**TOWN OF MOUNTAIN VILLAGE  
REGULAR DESIGN REVIEW BOARD MEETING AGENDA  
THURSDAY FEBRUARY 1, 2024, 10:00 AM  
MOUNTAIN VILLAGE TOWN HALL  
455 MOUNTAIN VILLAGE BLVD, MOUNTAIN VILLAGE, COLORADO  
TO BE HELD HYBRID THROUGH ZOOM:  
<https://us06web.zoom.us/j/86027664518>  
Meeting ID: 860 2766 4518**

**TO:** Mountain Village Design Review Board  
**FROM:** Claire Perez, Planner II  
**FOR:** Design Review Board Public Hearing; February 1, 2023  
**DATE:** January 15, 2023  
**RE:** Staff Memo – Initial Architecture and Site Review (IASR) Lot 1 Unit 1, TBD Eagle Drive.

C2

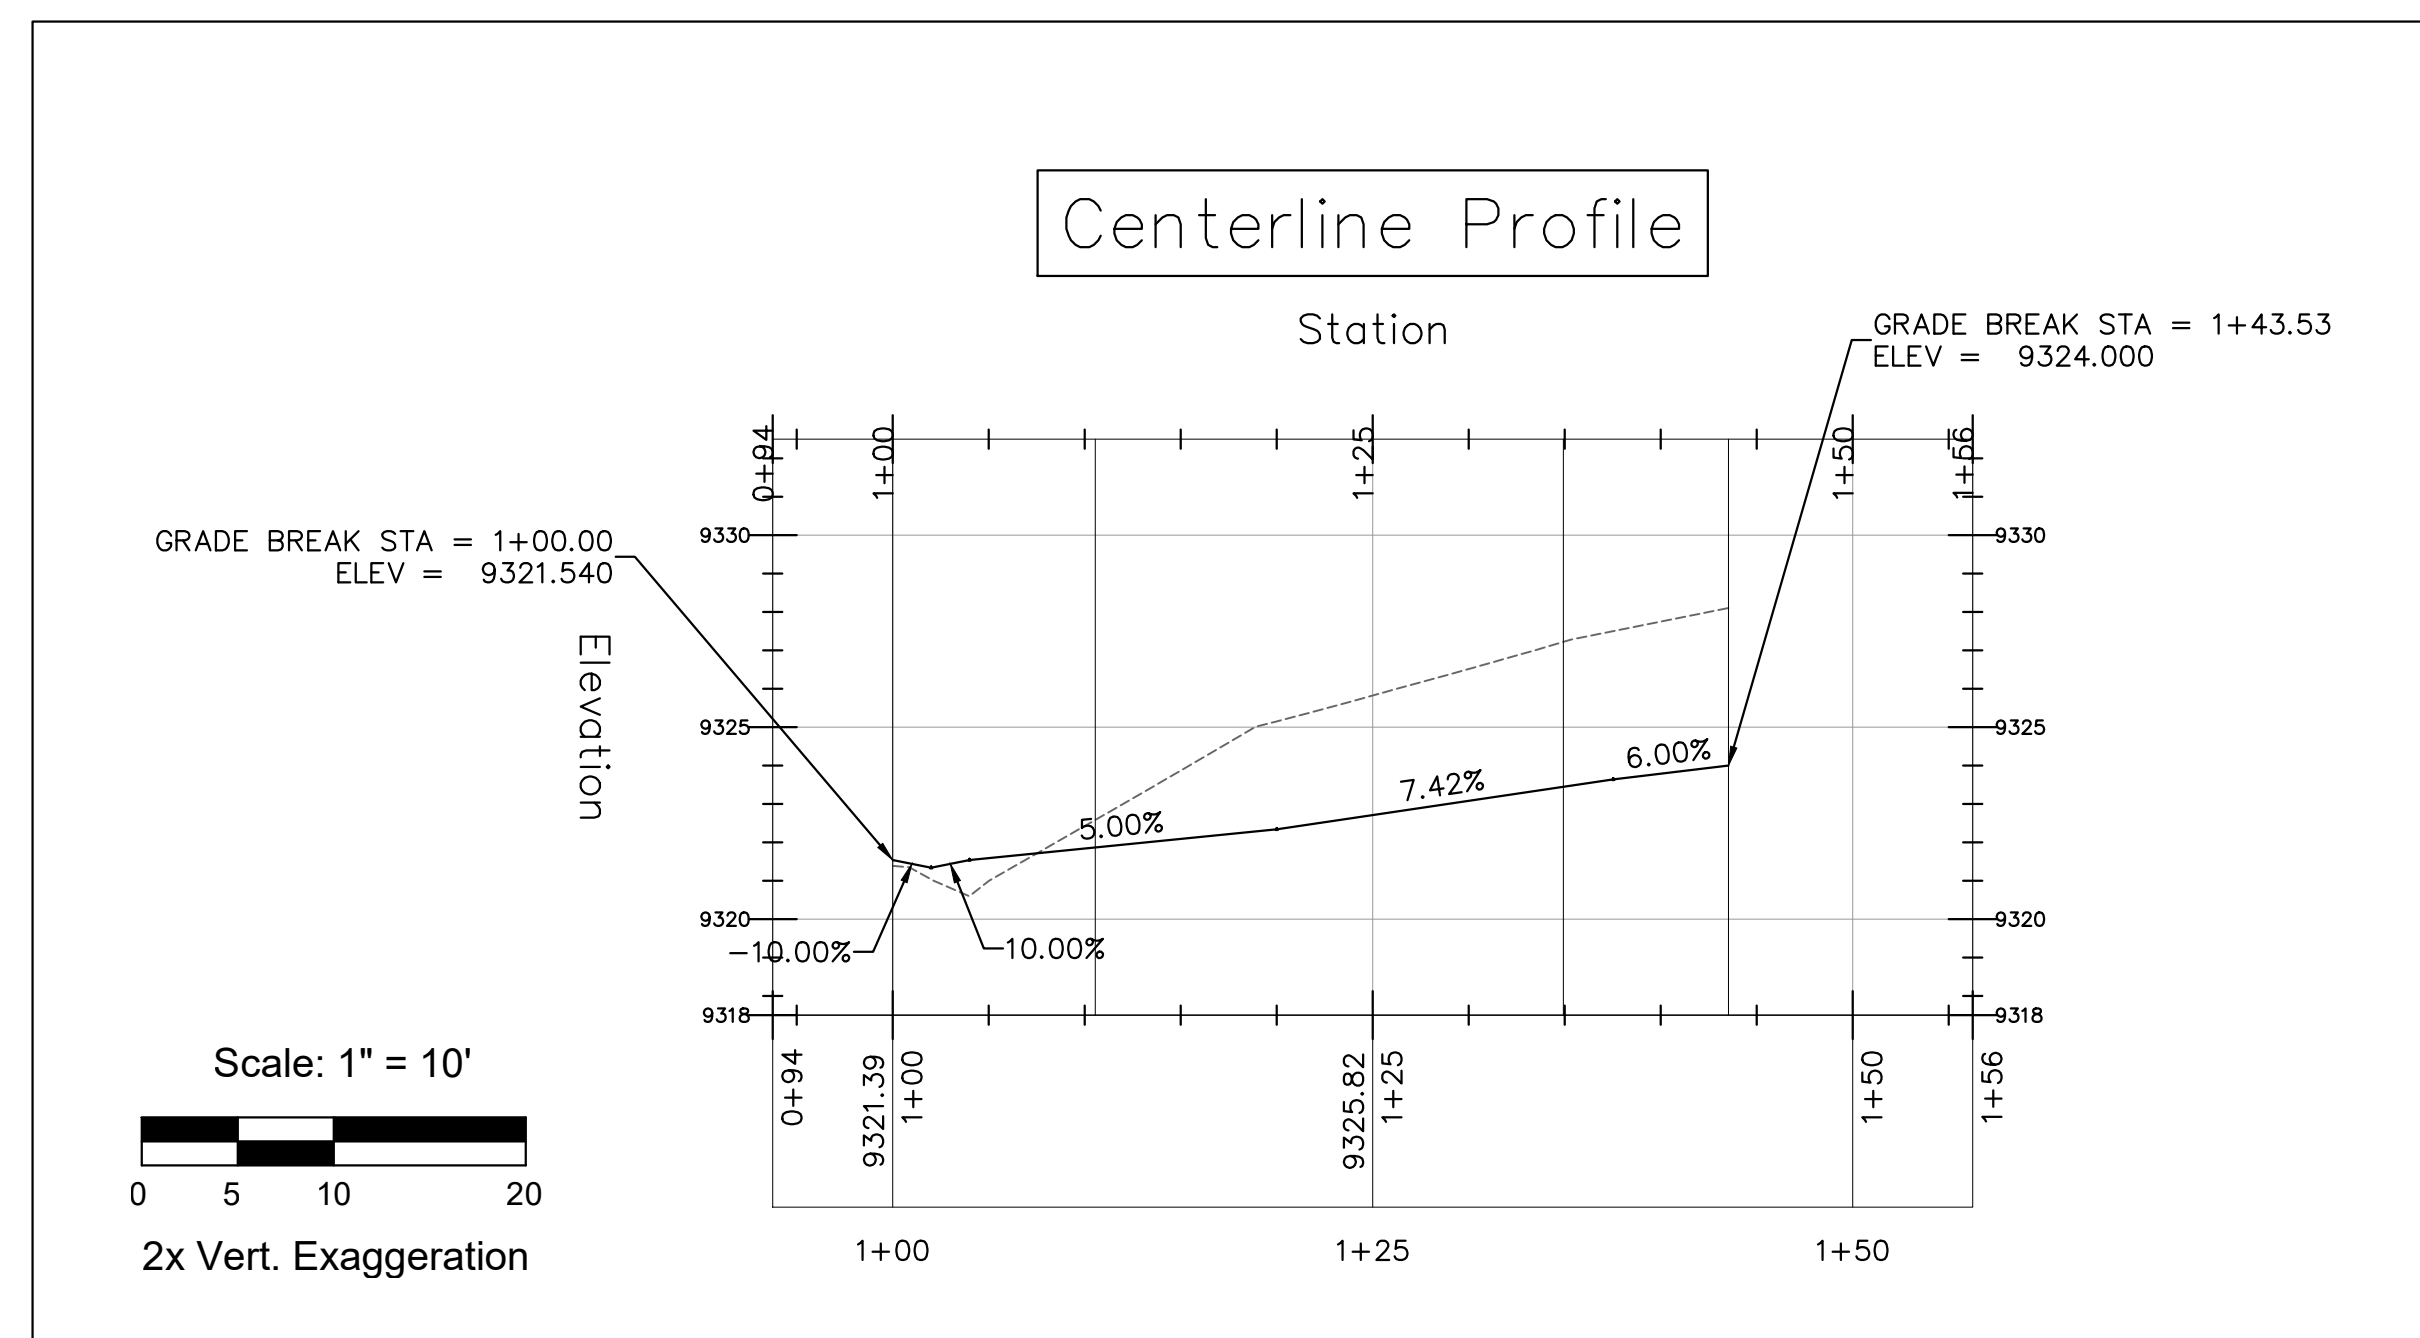
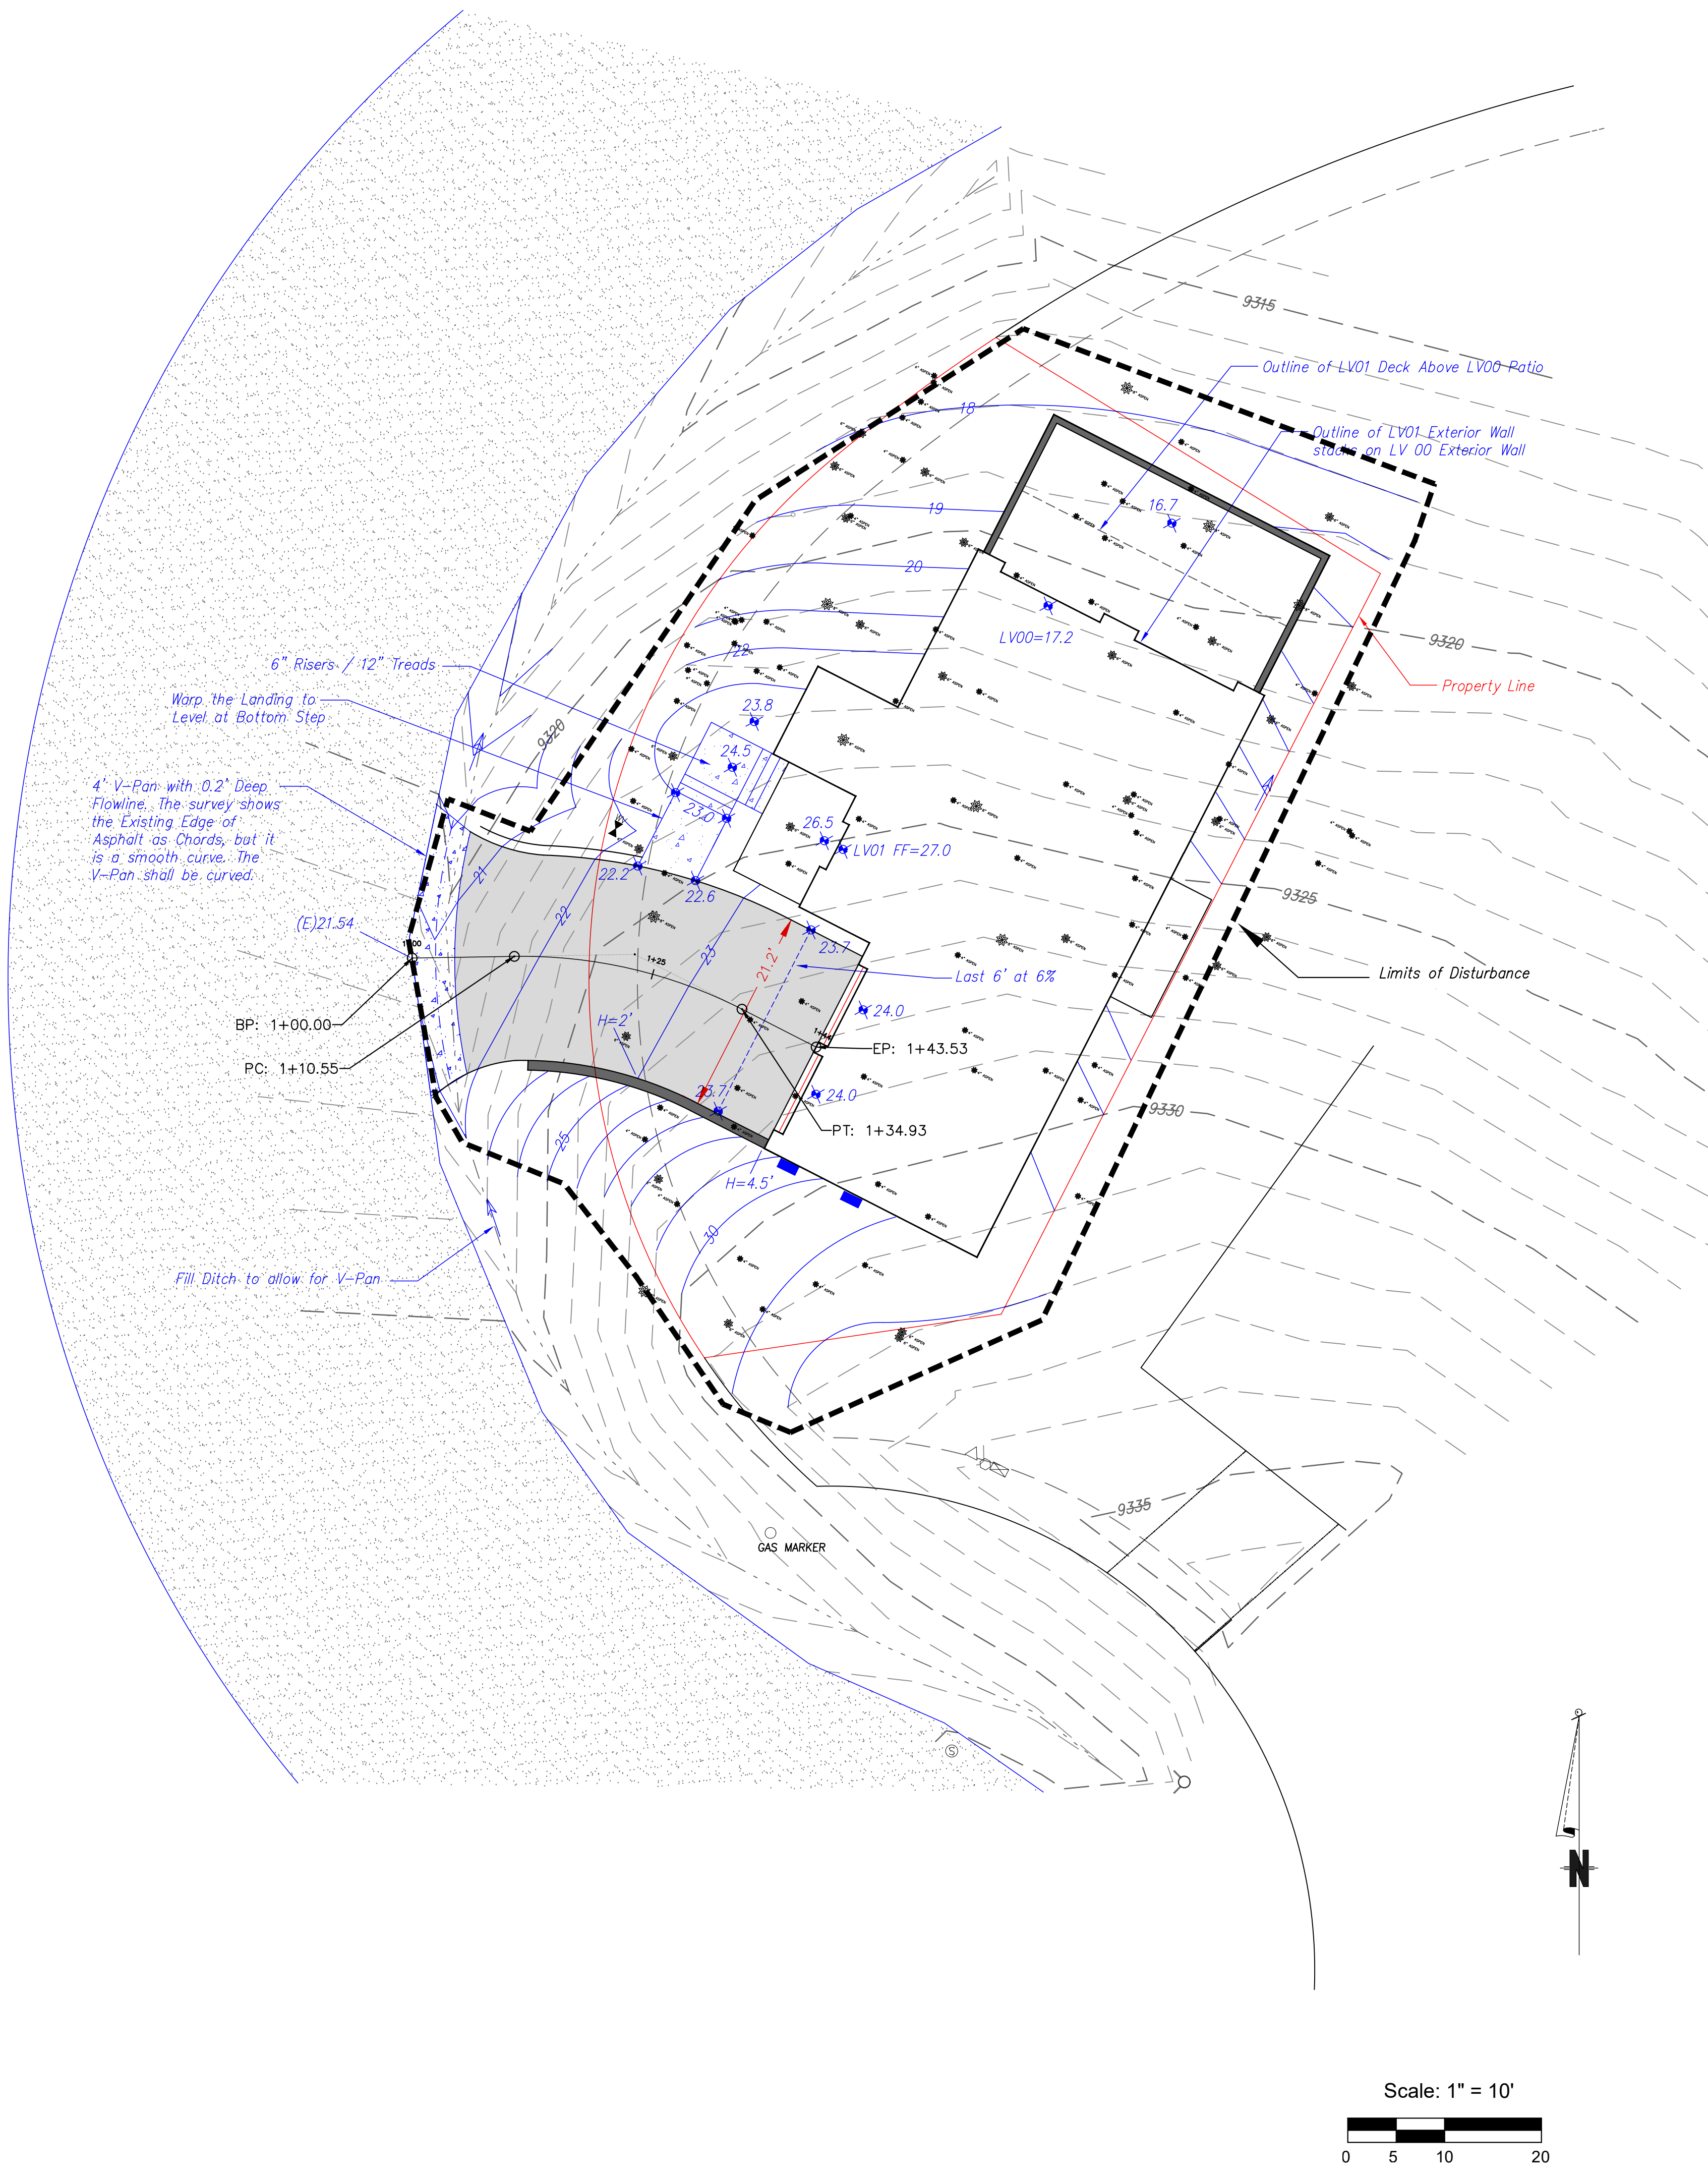
*Staff: The applicant has proposed grading into the northern, southern, and eastern GCE. Grading outside of the building envelope requires specific approval by the DRB. The grading plan appears to create positive drainage away from the home. Staff sees no issues with the grading plan.*

C4

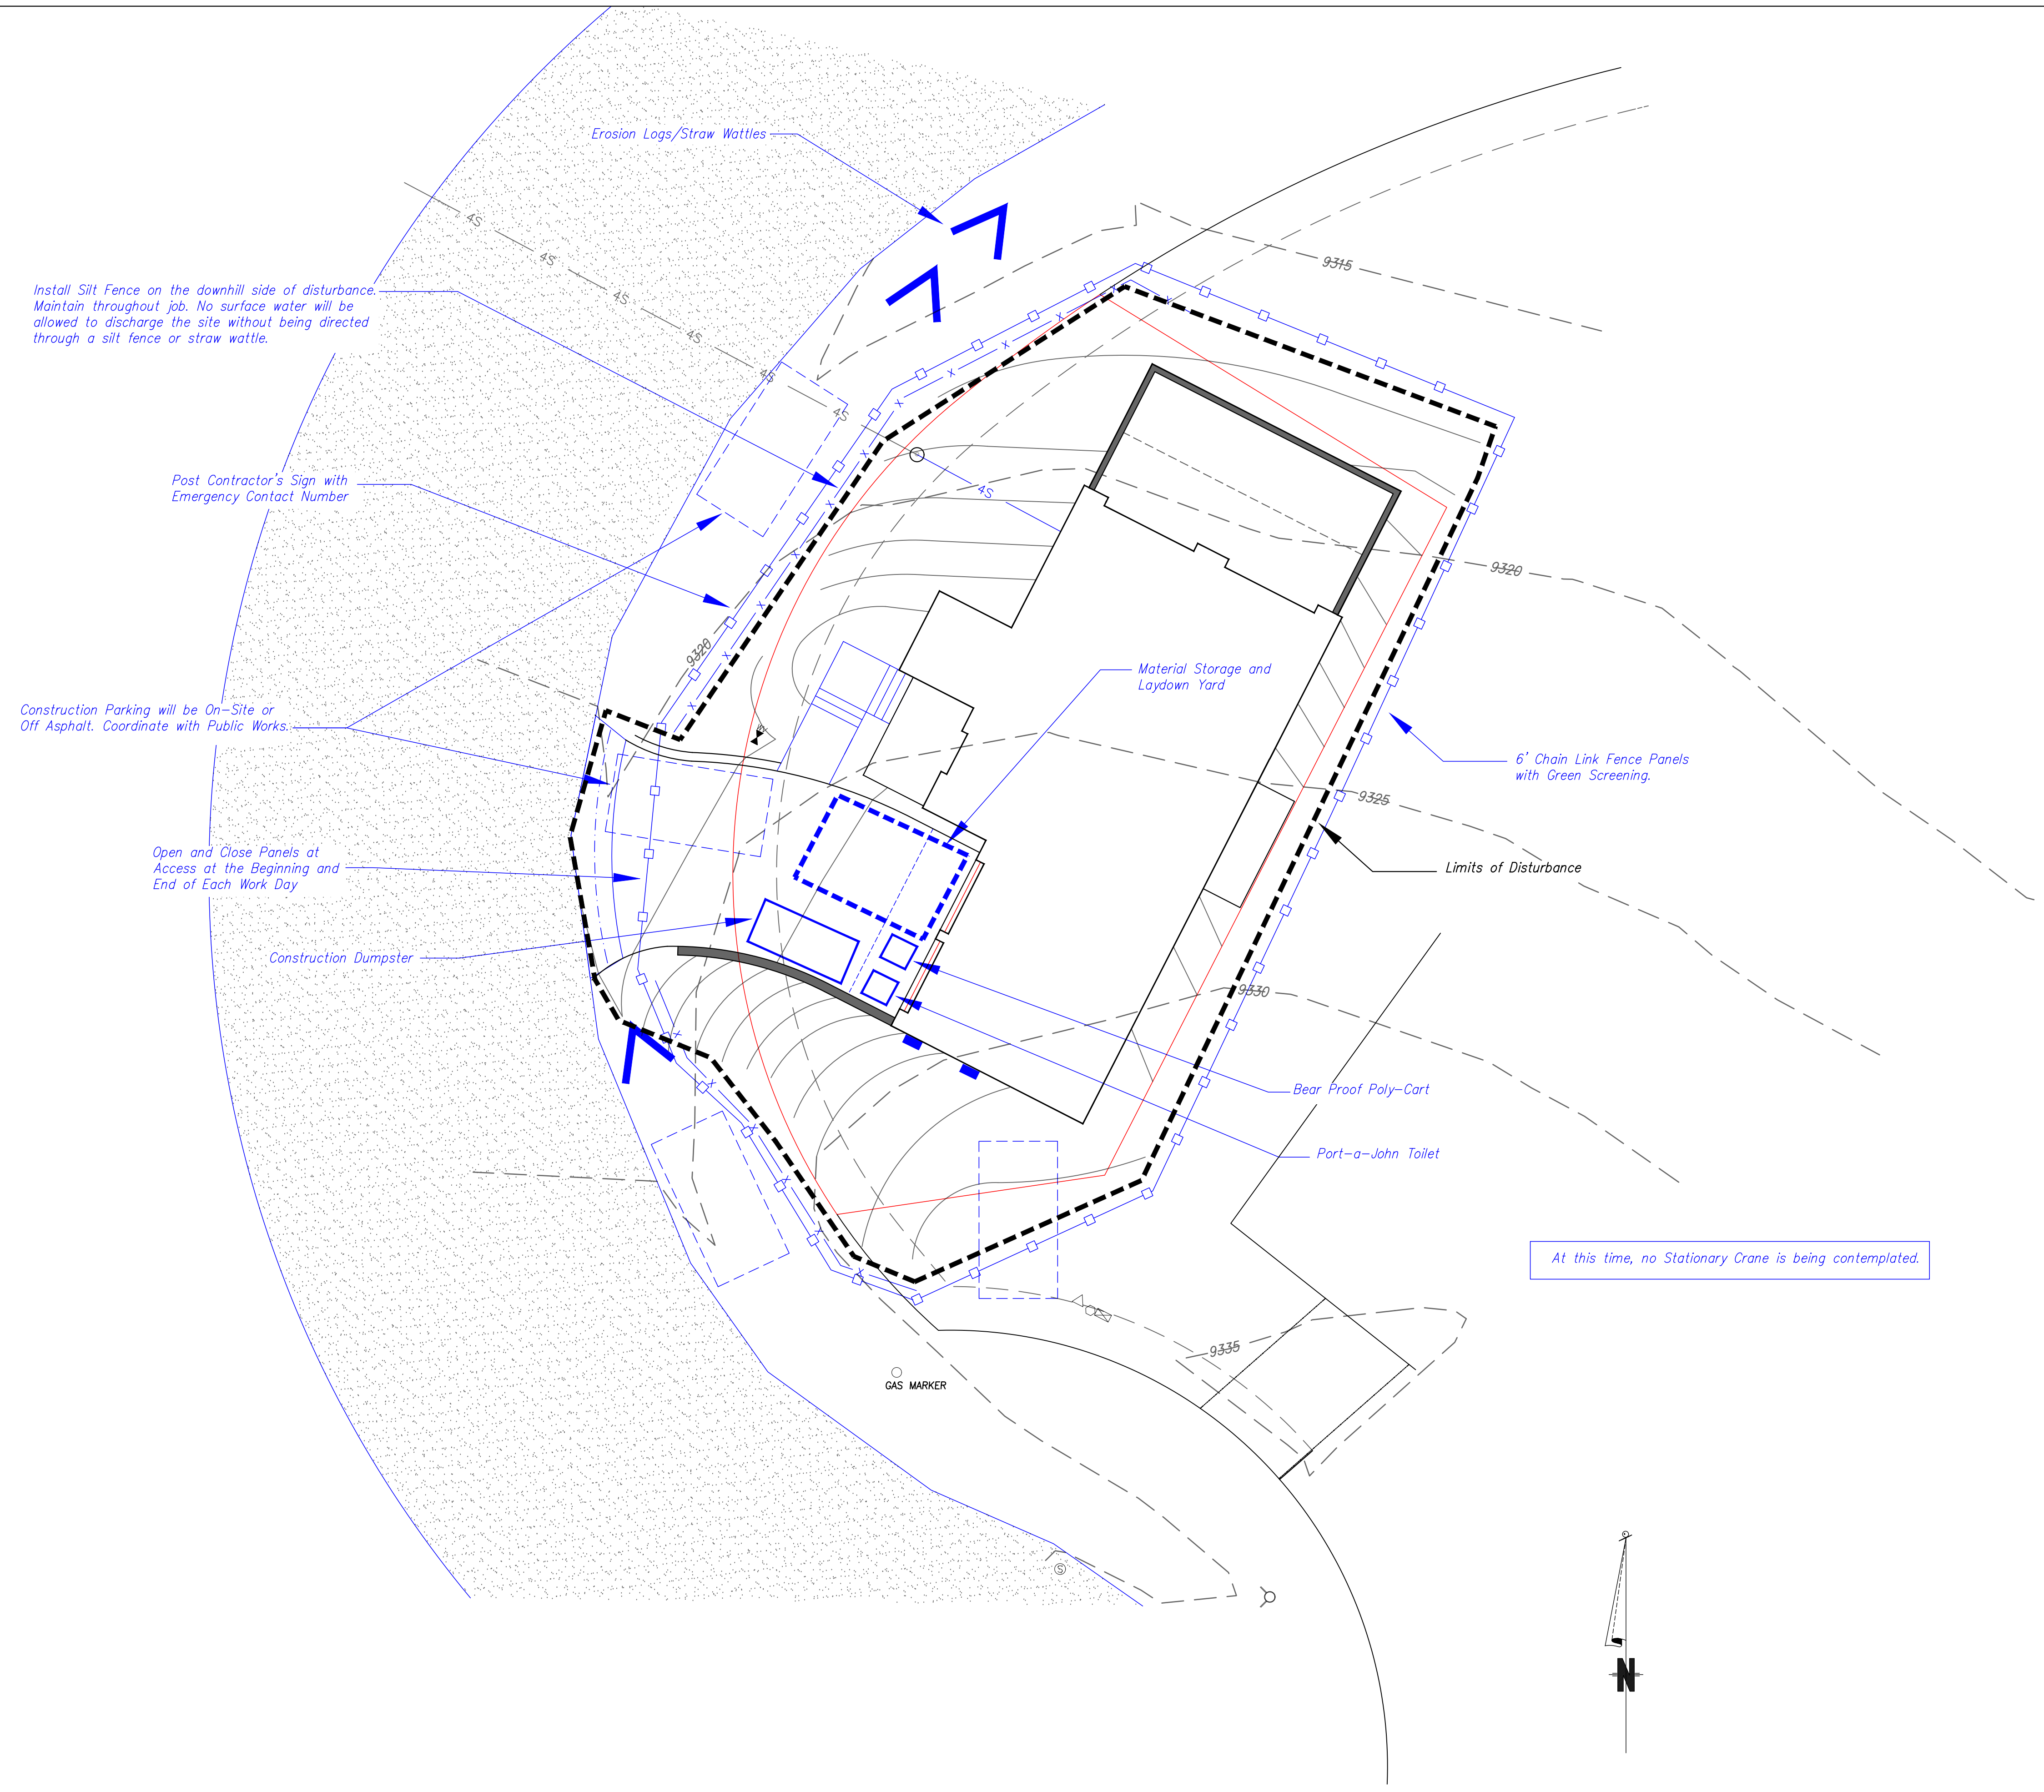
*Staff: A construction mitigation plan was provided on Sheet C4. The plan identifies the necessary construction dumpster, port-a-john, erosion control devices, material storage and laydown, and silt fencing. A parking space is provided in the driveway, which is an area that won't be available for use until the initial stages of construction are complete. Another parking space is shown in the right of way of Eagle Drive in the GCE. The applicant will need to obtain a right-of-way closure from the Town for the parking spot. Construction workers will likely need to be shuttled from off site during construction.*
